Re: 4101 Paseo Del Norte NE - Sports Complex
Request Permanent C.O. - Accepted
Engineer's Stamp dated: 6/11/2015 (C17D008)
Certification dated: 12-13-2017

**RE: Paseo del Norte Sports Complex, Tract A, Loop Industrial Park
Grading and Drainage Plan
Engineer's Stamp Date 6-11-2015 (File: C17-D008)**

From: Hughes, James D. <jhughes@cabq.gov>
Sent: Tuesday, September 19, 2017 9:35 AM
To: Matthew Satches; Wolfenbarger, Jeanne; Michel, Racquel M.
Cc: Bruce Stidworthy; 'rvsg7@rayleehomes.com'
Subject: RE: PDN Sportsplex (Hydro #C17-D008)

grading and
drainage plan

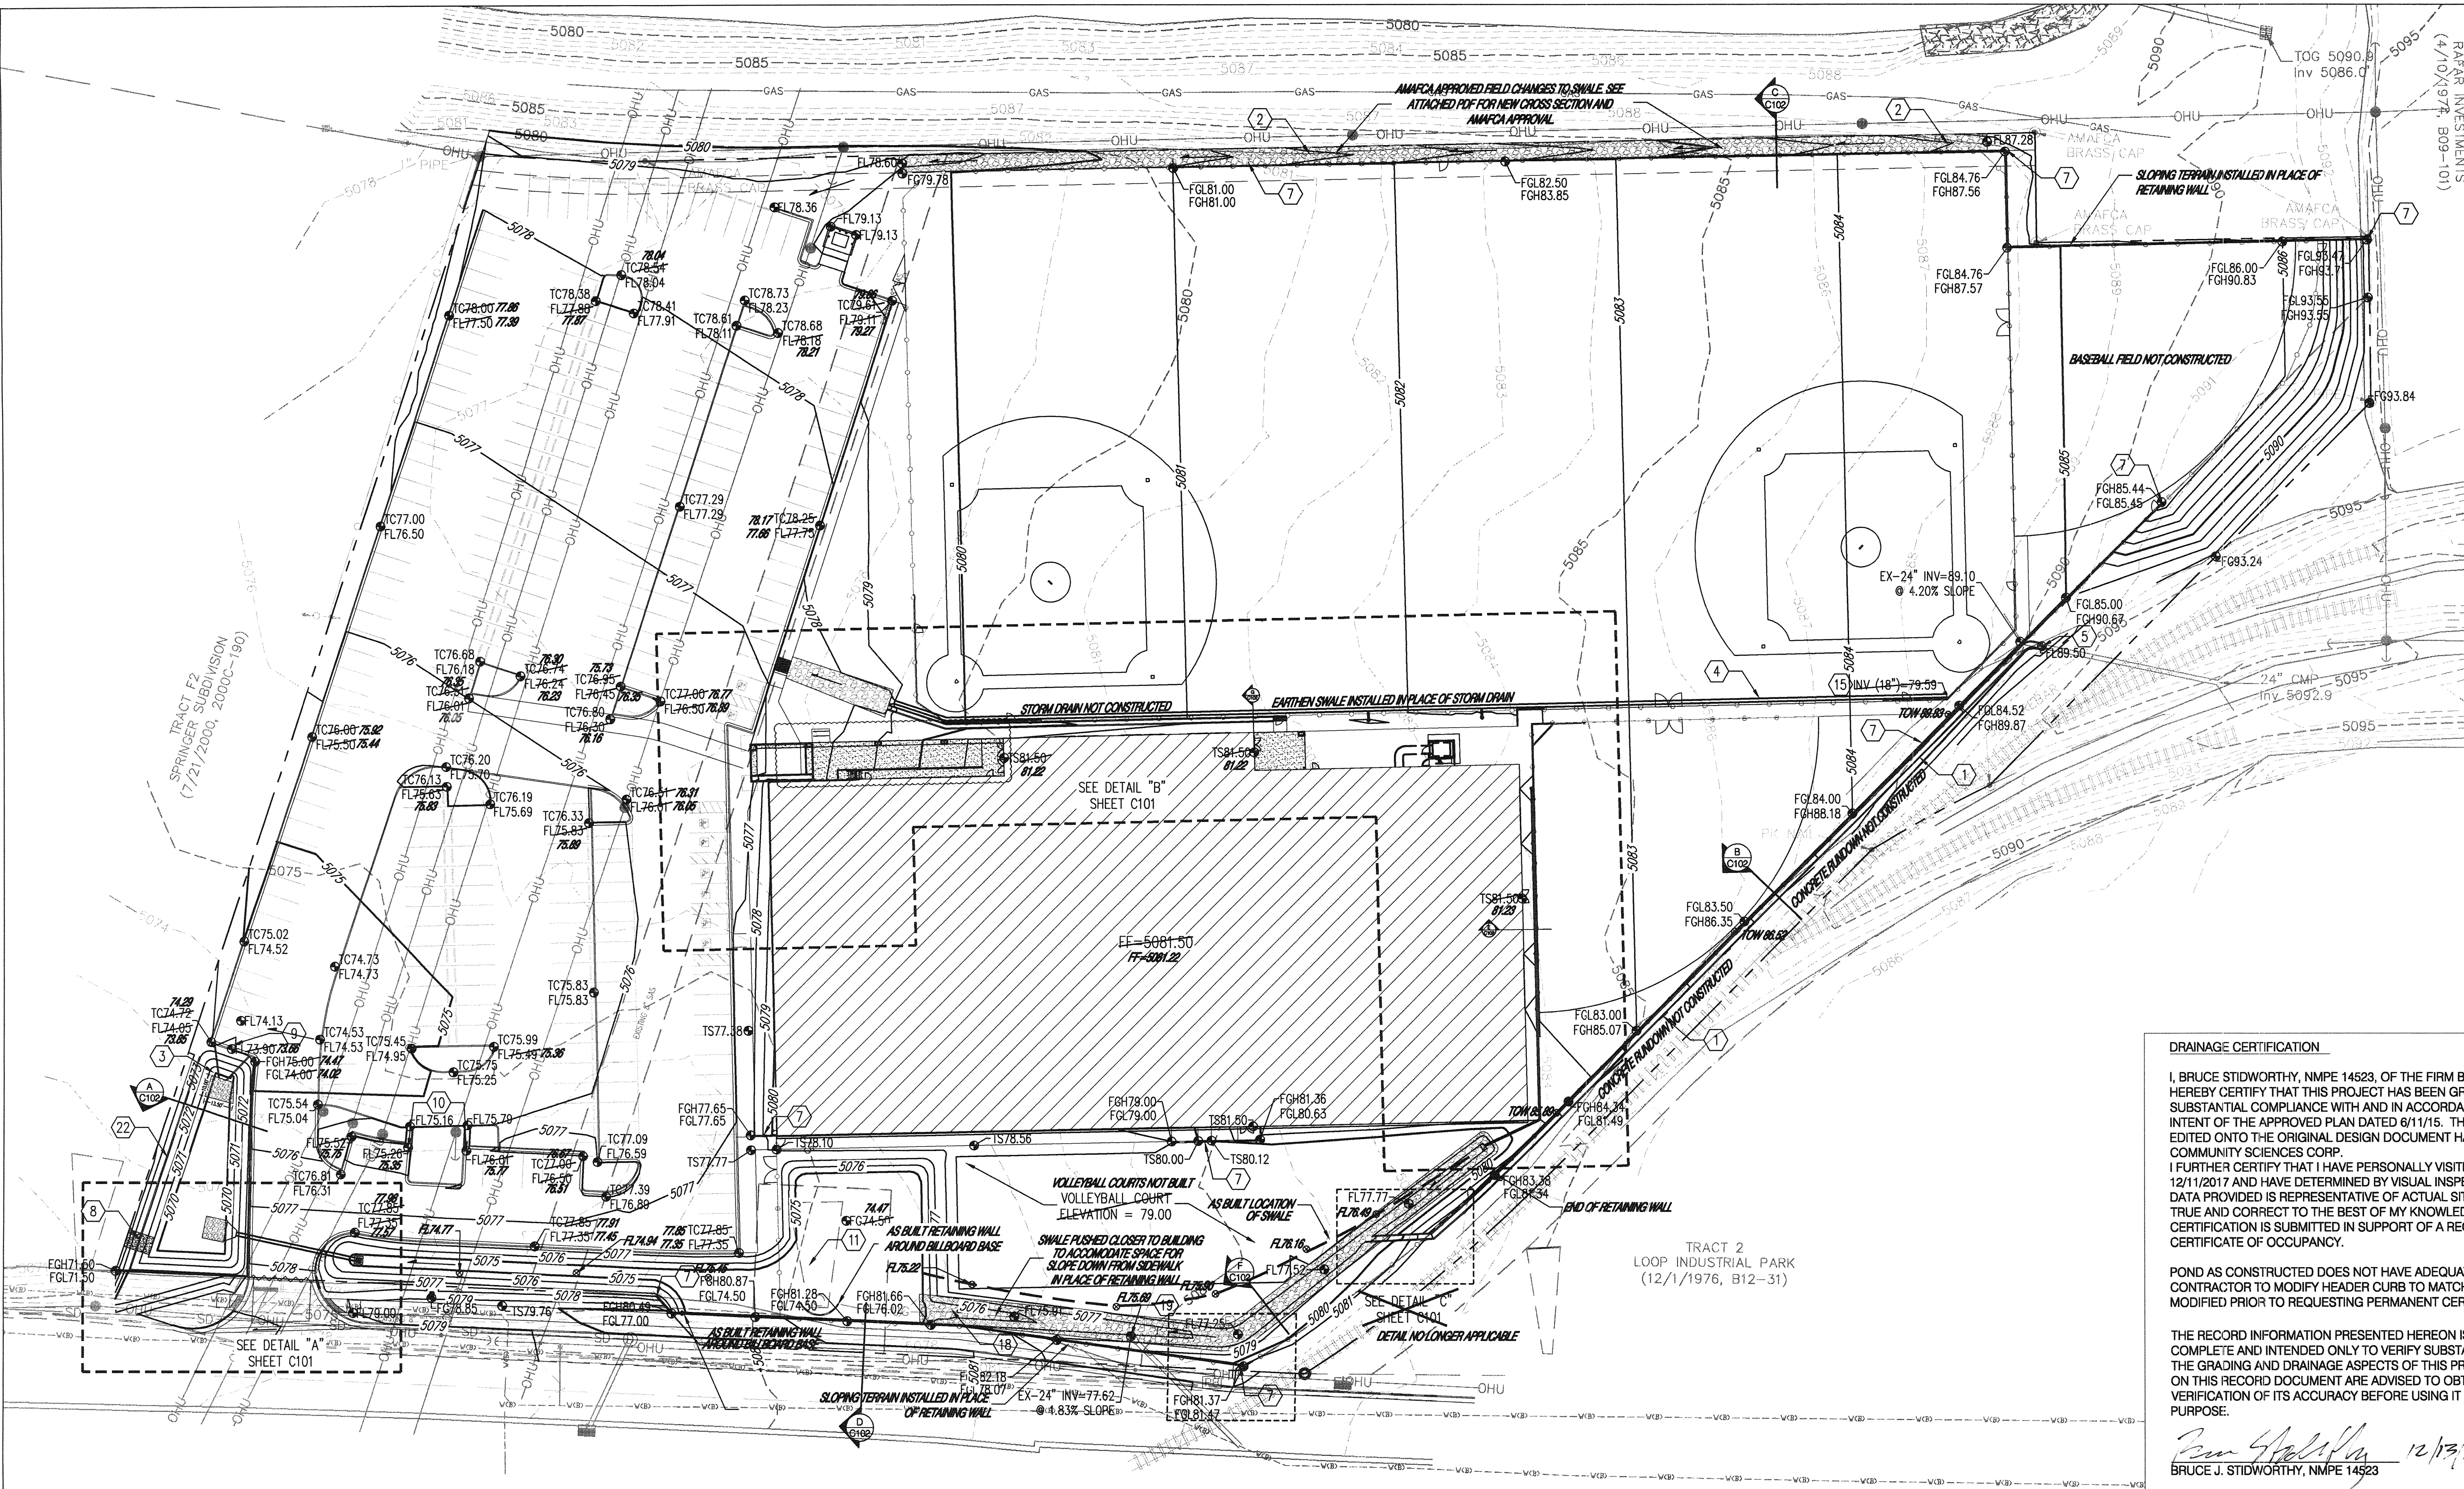
Our client has requested a slight change to the grading within the 15 Foot Easement that abuts the Domingo Baca Levee to the north of our site. Rather than installing a retaining wall, we would like to slope down to the finished grade of the field. At the bottom of the slope we will be installing a rip rap swale for nuisance flows from the south face of the levee. I've attached two exhibits, one showing the original design and one showing the new design. Can you please confirm that this change is acceptable?

AMAFCA approves the revised plan concept. I have a few comments.

1. Show the size and type of rock to be used in the swale. It should be small enough to allow a person to walk on it. Use filter fabric under the rock.
2. Show where the swale outfall is.
3. The side slope should be reseeded. No woody shrubbery will be allowed. I can provide a mix.

date
8-31-15
sheet
c100

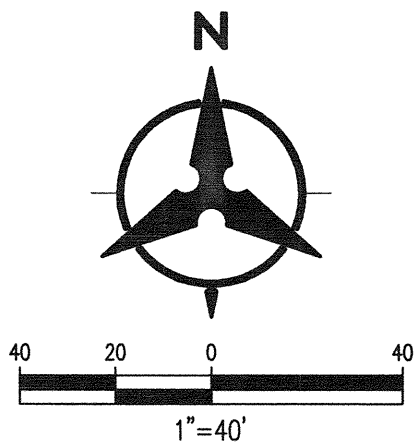
POND AS CONSTRUCTED DOES NOT HAVE ADEQUATE FREEBOARD. CONTRACTOR TO MODIFY HEADER CURB TO MATCH DESIGN AND WILL BE MODIFIED PRIOR TO REQUESTING PERMANENT CERTIFICATE OF OCCUPANCY.
